From: [Joe Stockton](#)
To: [Daniel Davies](#)
Cc: [Reg13](#)
Subject: RE: MSG revised TA 2020
Date: 02 December 2020 14:26:04
Attachments: [Letter to Pinsent Masons 1 October 2020 pdf](#)

MSG Sphere – Response to MTR Elizabeth Line comments (9th December 2020)

Point 3

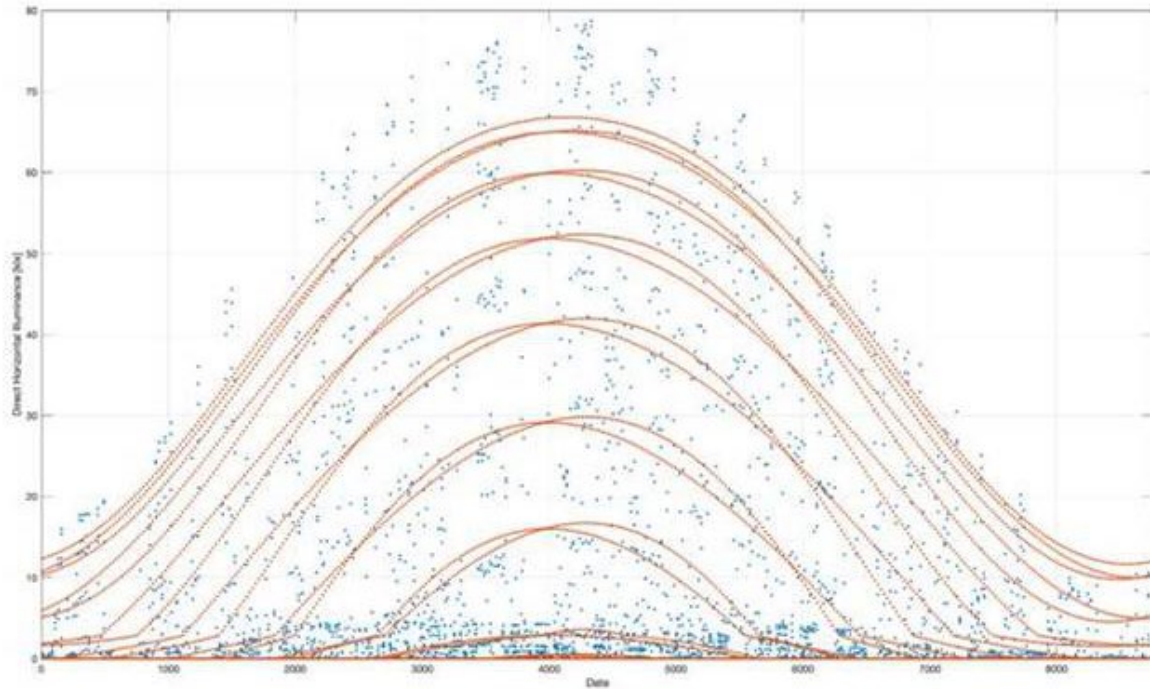
Accepted

The veiling luminance values were calculated using evalglare. A typical command line would read:
evalglare -b 5000 -d hdrfile
